Office Action Summary	Application No.	Applicant(s)	
	10/663,107	TSUCHIZAKI, AKIHIRO	
	Examiner	Art Unit	
	Amy J. Sterling	3632

This is the first Office Action for application number 10/663,107 License Plate Holding Bracket and the Holding Structure thereof, filed on 9/16/03. Claims 1-21 are pending. This application claims priority to Japan 2002-270020, 2002-270040, 2002-270044, 2002-270109, 2002-270116 all dated 9/17/02.

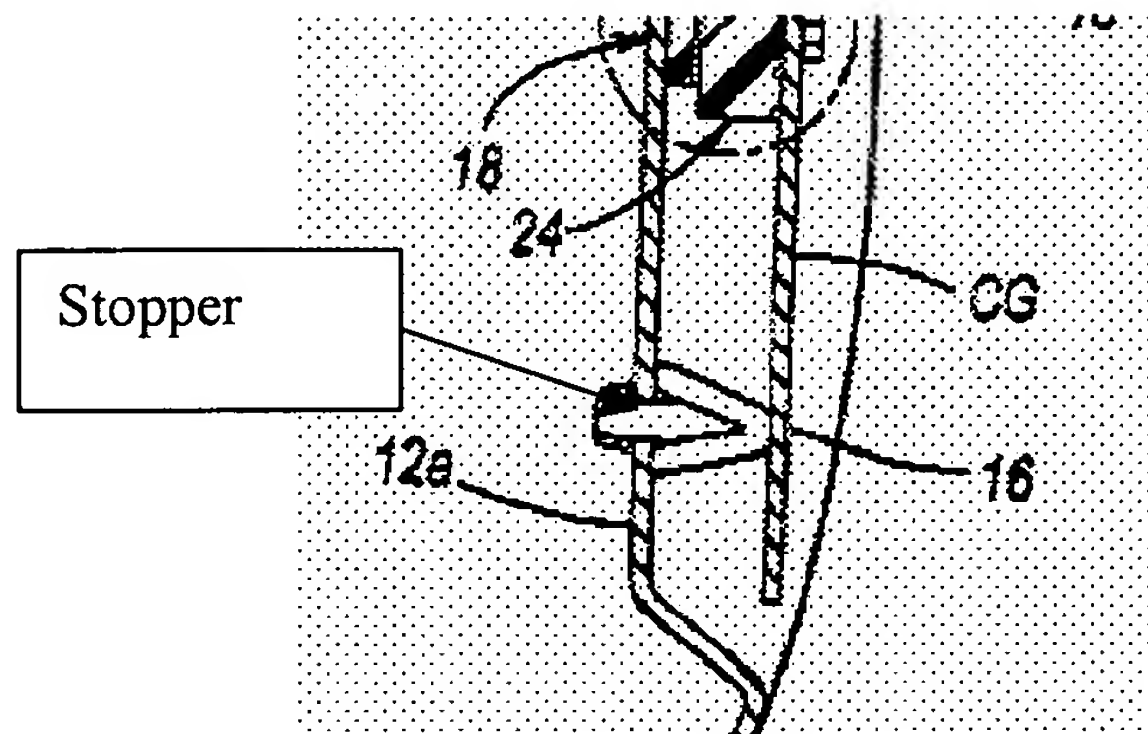
Smith discloses applicant's basic inventive concept including wherein the end side of the fixing member and the plate holding member are connected and both have a plane shape, and a stopper member (See Drawing Below, Fig. 6).

Smith does not teach wherein the stopper member resides on the plate holding member and is brought into contact with the rear bumper of a vehicle when the tailgate is horizontal and the license plate is almost erect with respect to the tailgate and contacts the tailgate and the gate side fixing member when the license plate is parallel to the tailgate and wherein the tailgate has a cavity for receiving the stopper.
